工程指示 / 要求簡箋(E.I.)

工程指示編號：EI / 7232 / 24                      修改版次：B  
 工程編號           ：J - 858                              工程名稱       ：將軍澳日出康城  
 工程項目           ：後加 AC Grille (T2 9/F AF Mock Up) 圖紙上載 2<sup>nd</sup> submission  
 收件人               ：生統 / 拆圖                              發件人        ：Paul Wong                              日期：22/02/2024

**PROPOSED RESIDENTIAL DEVELOPMENT  
AT TKOTL 7ORP, PHASE 11, LOHAS PARK, TSEUNG KWAN O, N.T.**

**TITLE : SHOP DRAWING FOR  
ALUM. A.C. GRILLE & WATER CABINET AT 9/F FOR TOWER 2A-FLAT F (MOCK UP)**

TITLE :  
ALUM. A.C. GRILLE & WATER CABINET  
AT 9/F  
FOR TOWER 2A-FLAT F  
ELEVATION

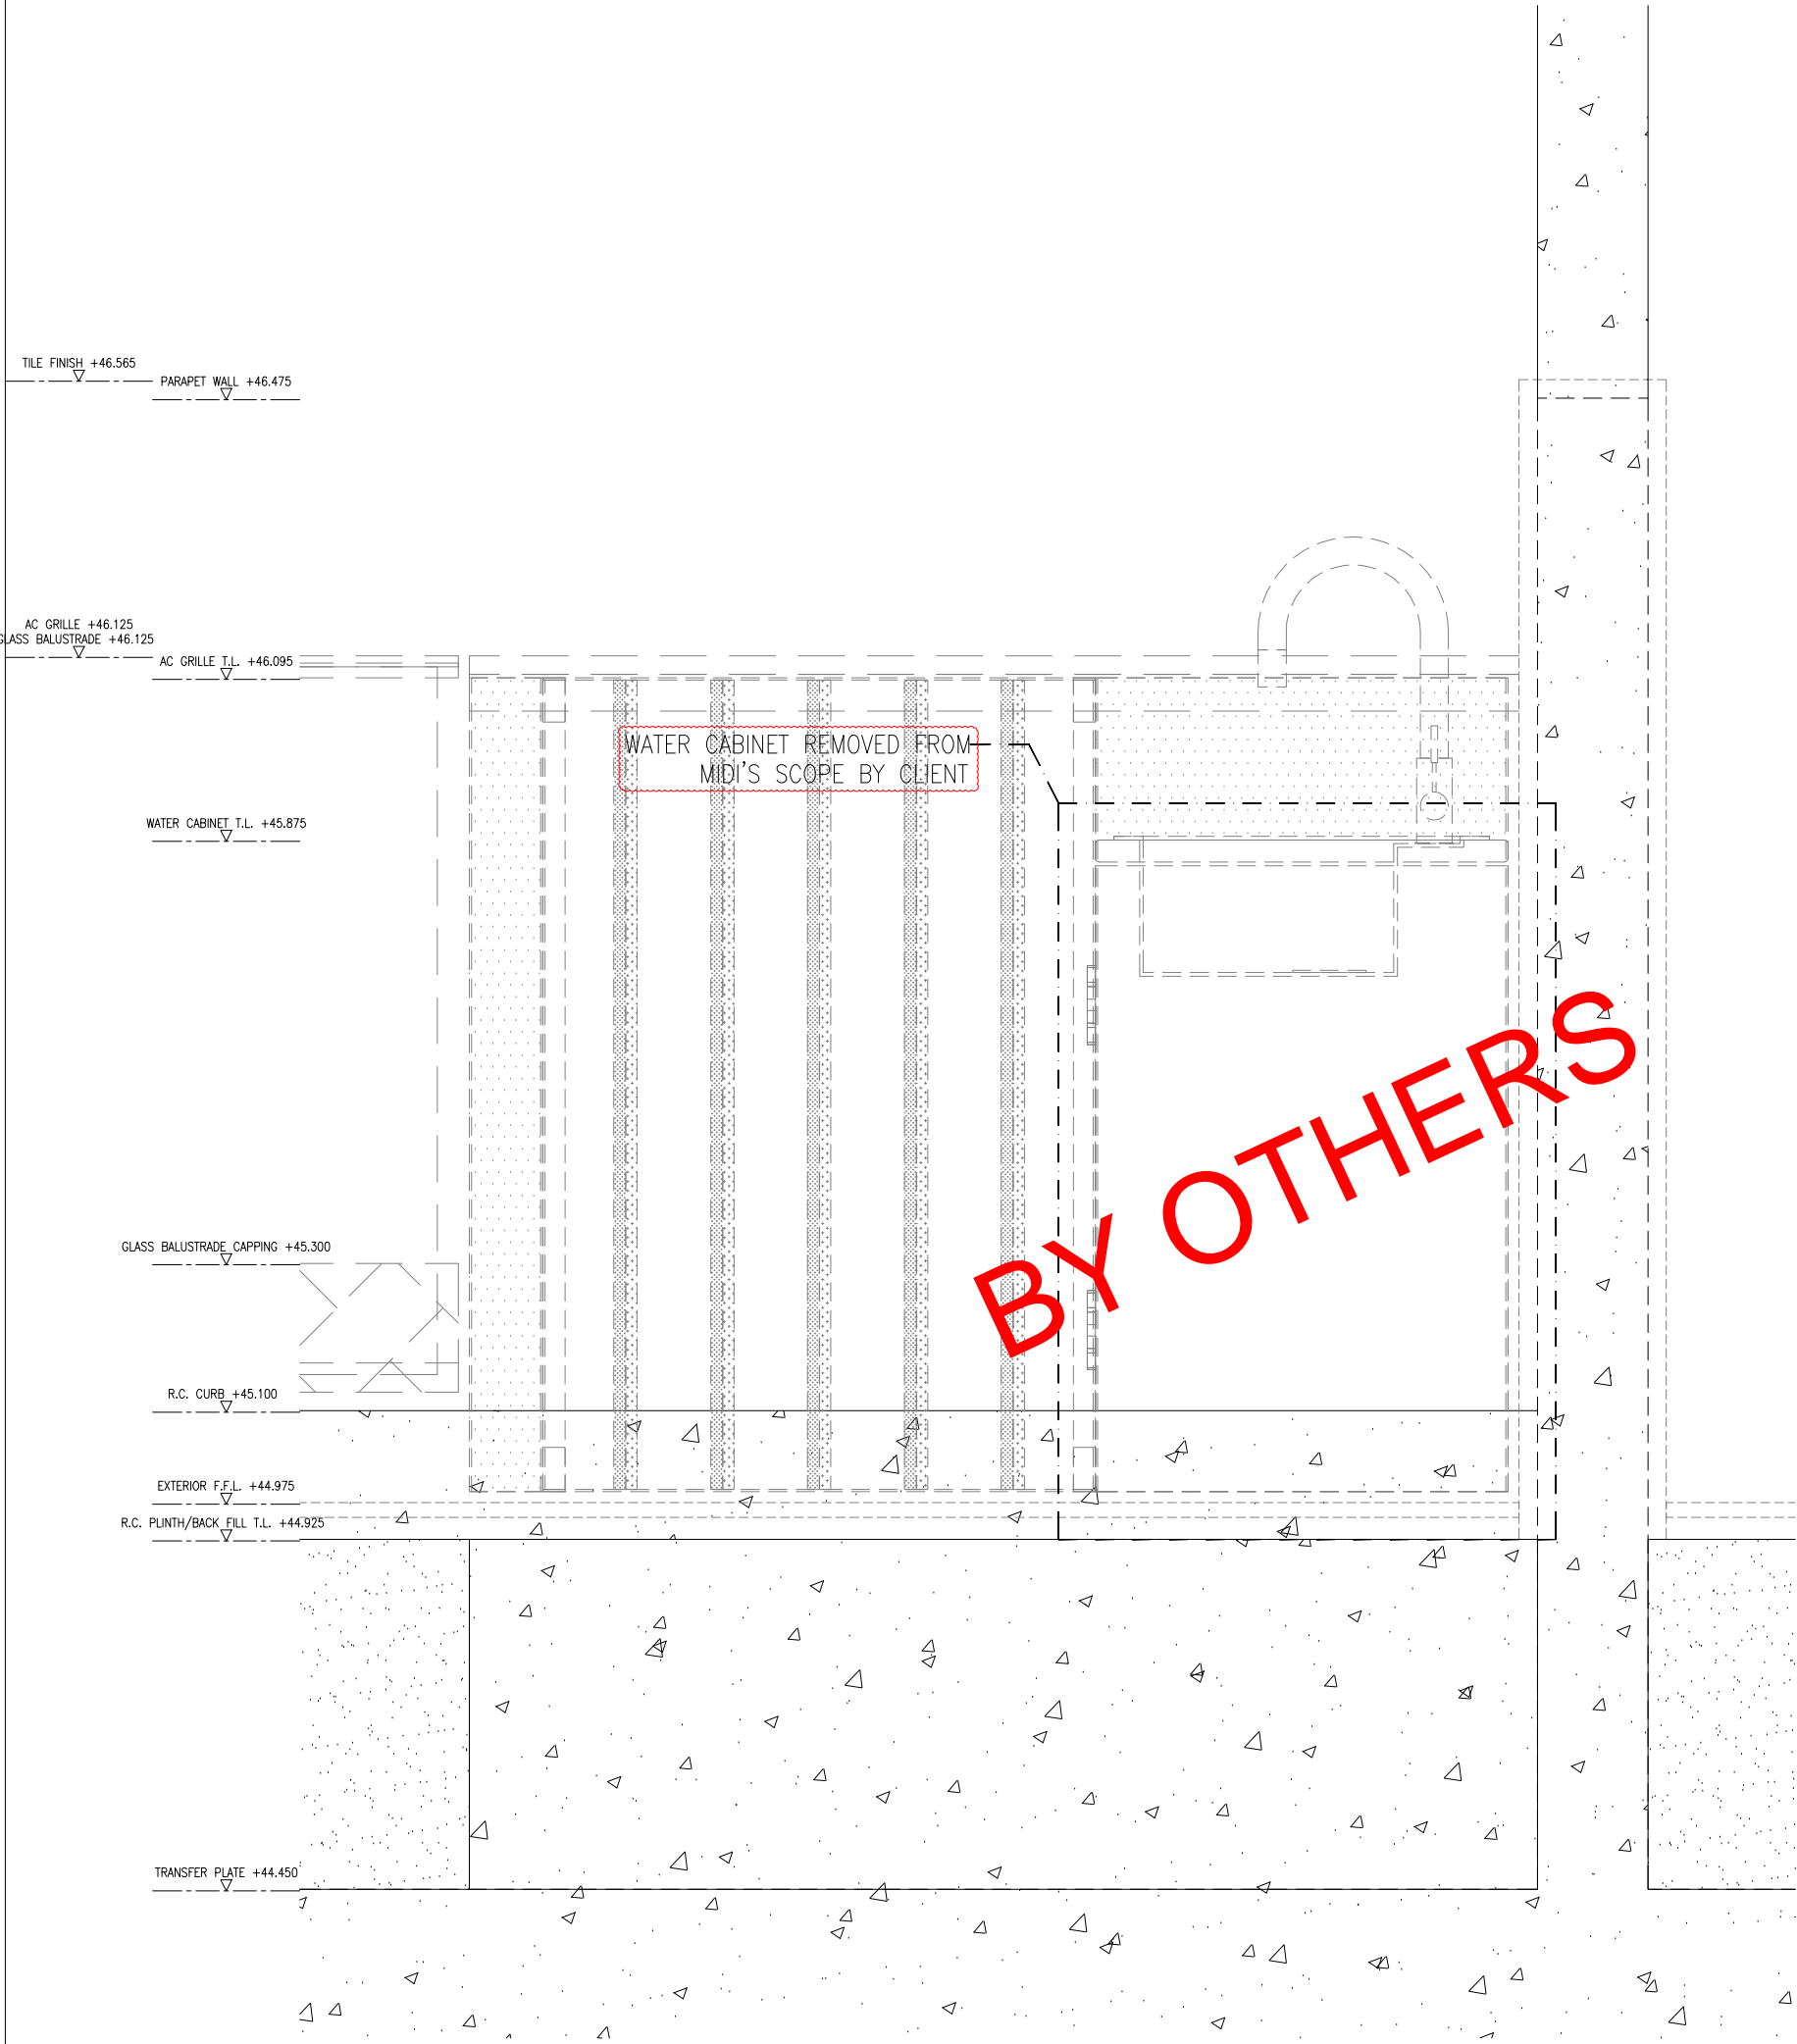
WATER CABINET REMOVED FROM  
MIDI'S SCOPE BY CLIENT

TITLE : ALUM. A.C. GRILLE & WATER CABINET AT 9/F FOR TOWER 2A-FLAT F TYPICAL DETAILS

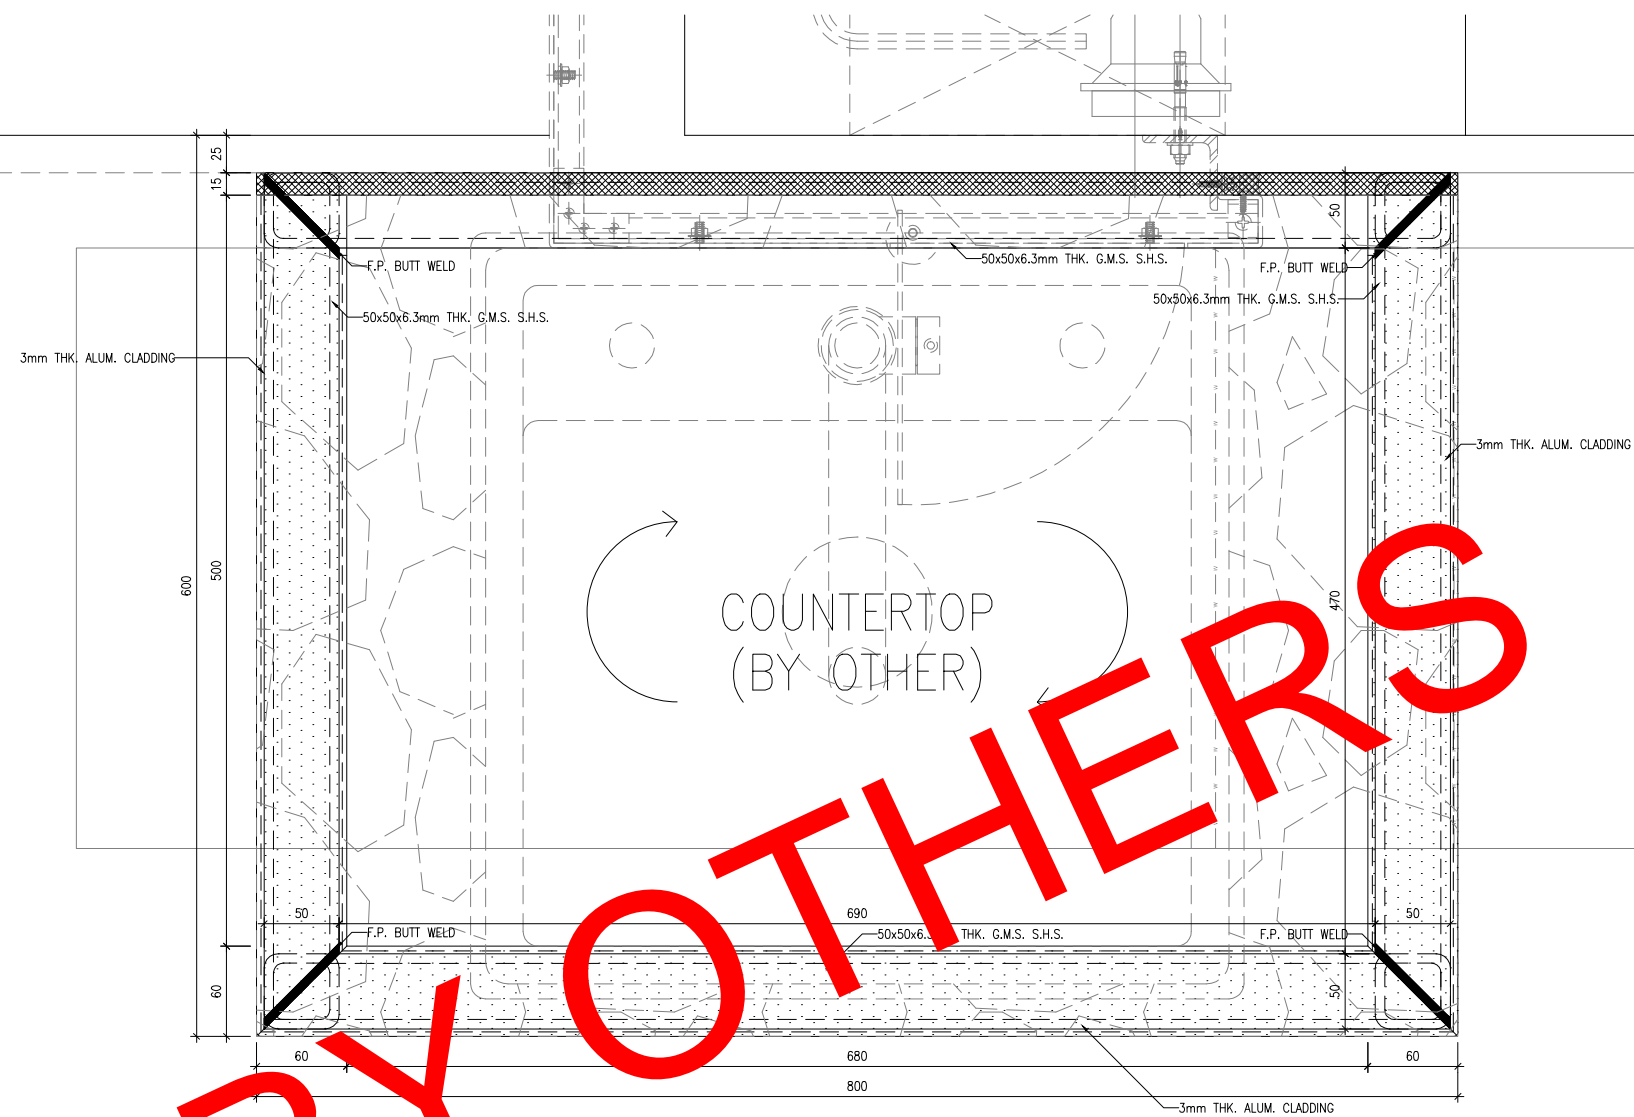
WATER CABINET REMOVED FROM MIDI'S SCOPE BY CLIENT

TITLE :  
ALUM. A.C. GRILLE & WATER CABINET  
AT 9/F  
FOR TOWER 2A-FLAT F  
TYPICAL DETAILS

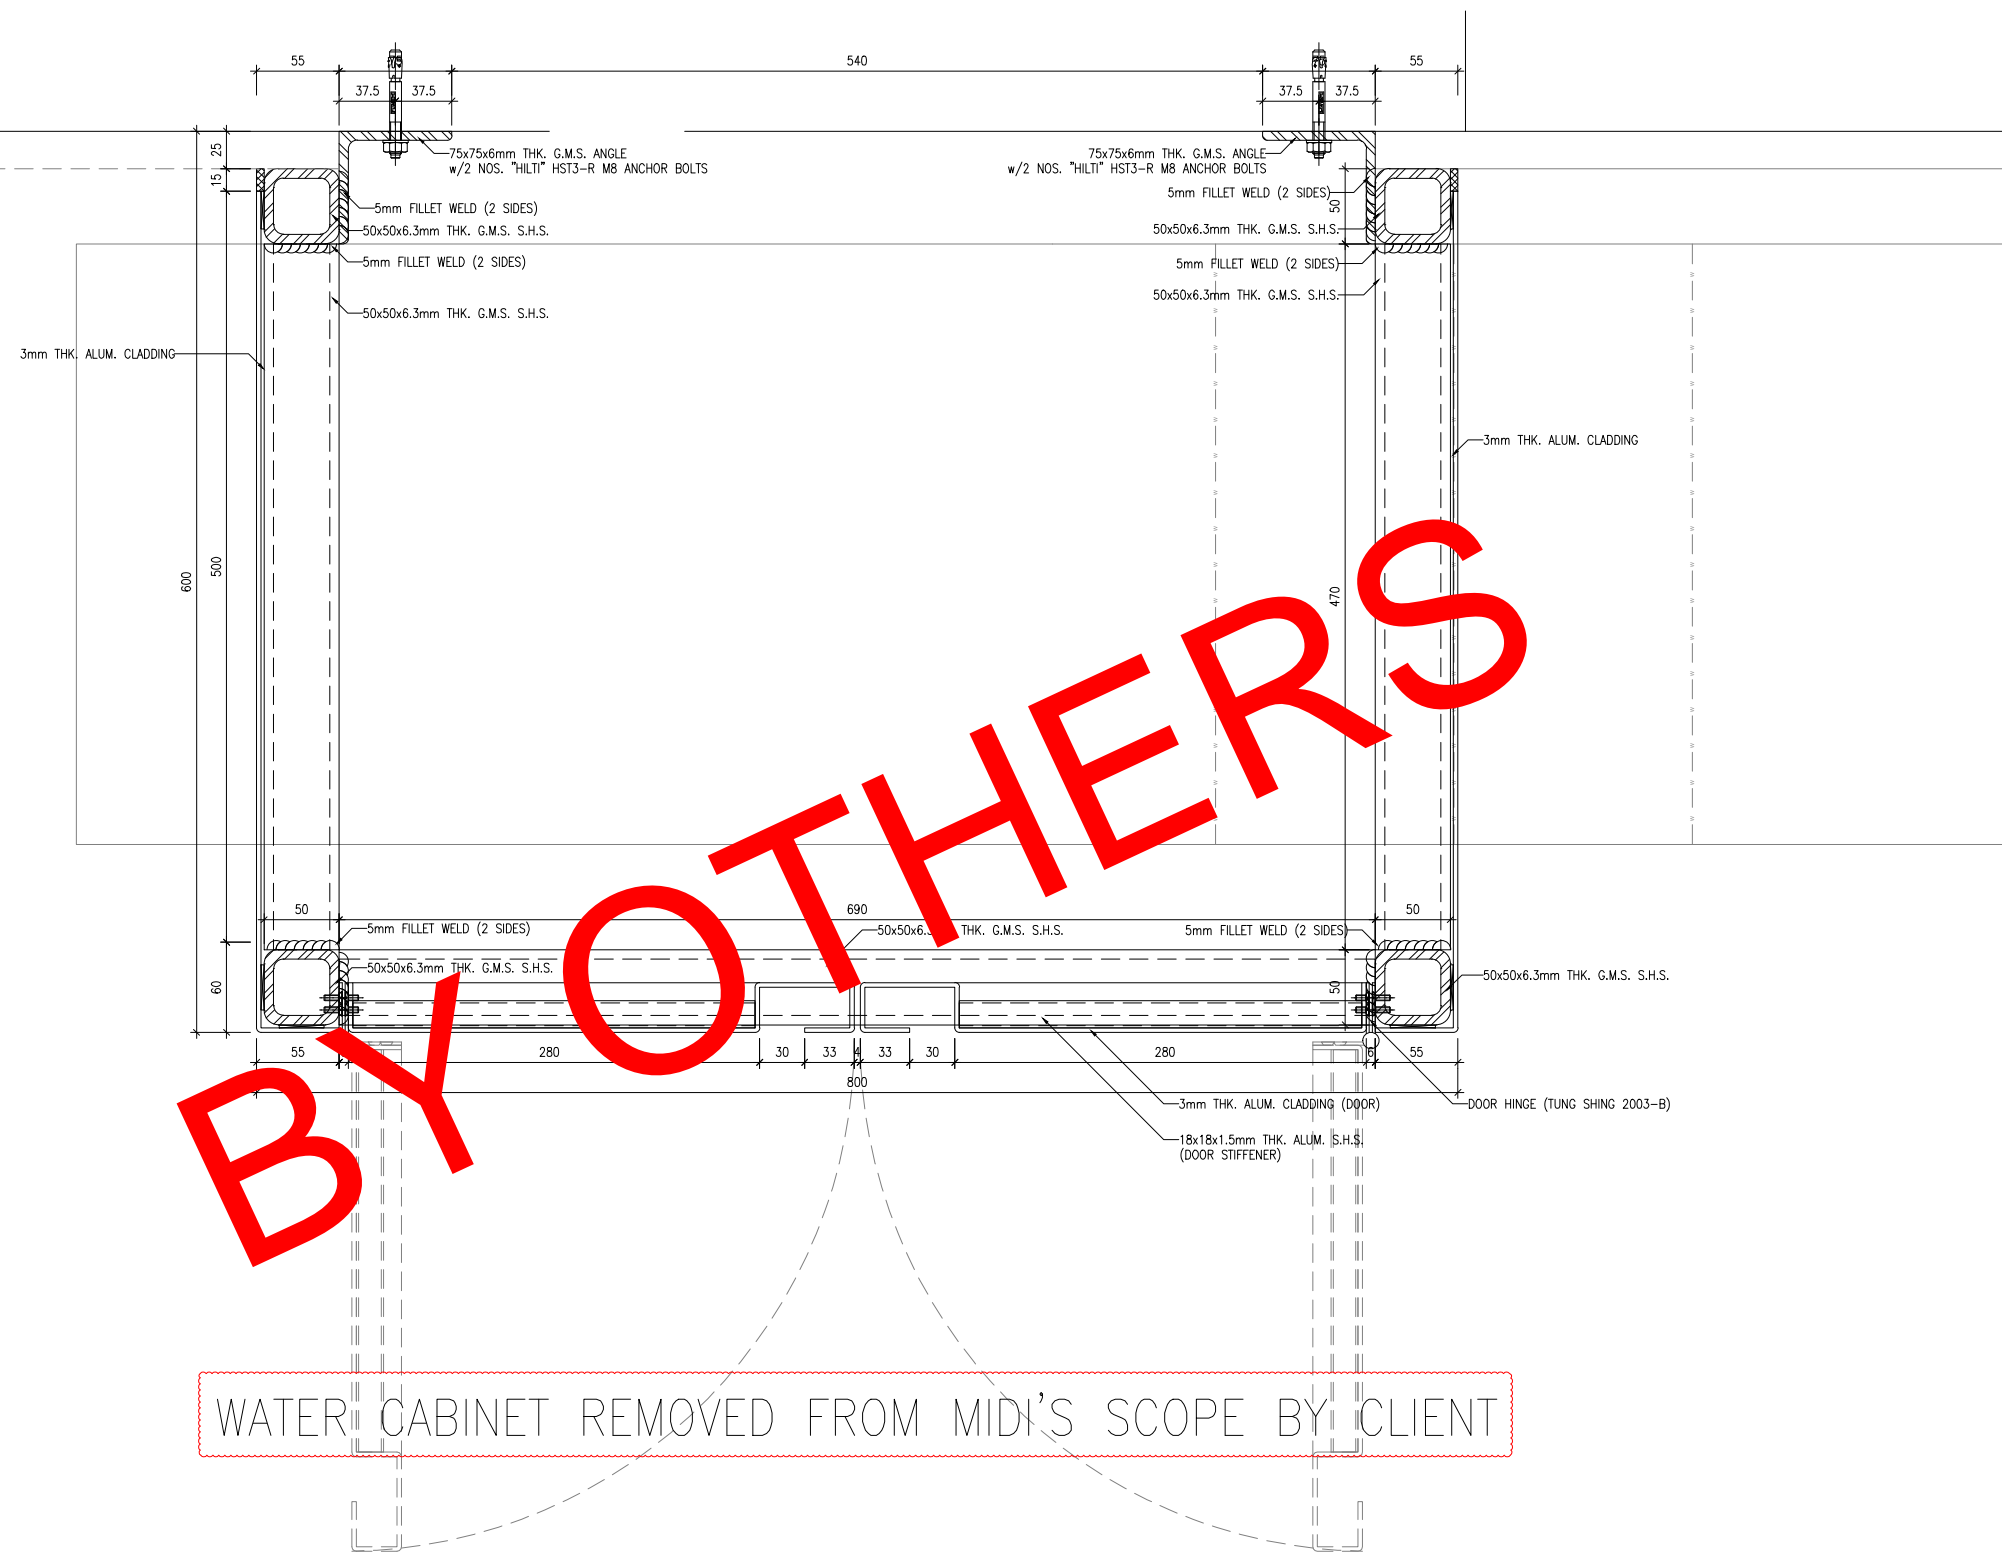
WATER CABINET REMOVED FROM MIDI'S SCOPE BY CLIENT
